Service Bulletin

Bulletin No.: 23-NA-082

Subject: Information for Vehicles Having Rear Park Assist Button But Rear Park Assist Does
Not Function

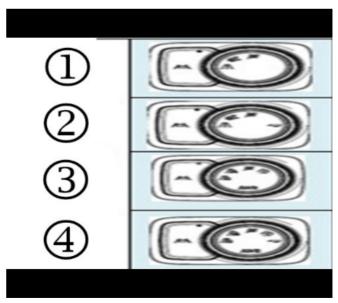
Involved Region or Country	Middle East, Israel, Chile (West), Colombia (West), Aruba, Cayman Islands, Costa Rica, Curacao, St Martin, Honduras, Nicaragua			
Additional Options (RPOs)	Equipped with PARK ASSIST-REAR, LANE ACTIVE SAFETY-KEEP ASSIST, DELETE CODE PARK ASSIST (RPOs UD7, UHX, 060)			
Condition	Some customers may comment on having a rear park assist button, but the rear park assist does not function.			
Cause	The condition is due to a design change to remove the rear park assist system complete with NO retrofit. The 2023 Blazer will never have a functional rear park assist system even though some vehicles were built with a ride control switch that still contains the rea park assist button on it. Note: This button DOES NOT function and has NO effect on how the vehicle operates.			
Correction	If the customer desires to have the correct ride control switch without the rear park assist button, replace the ride control switch.

Remove the front floor console trim to remove the ride control switch. Refer to Front Floor Console Trim Plate Replacement in SI.
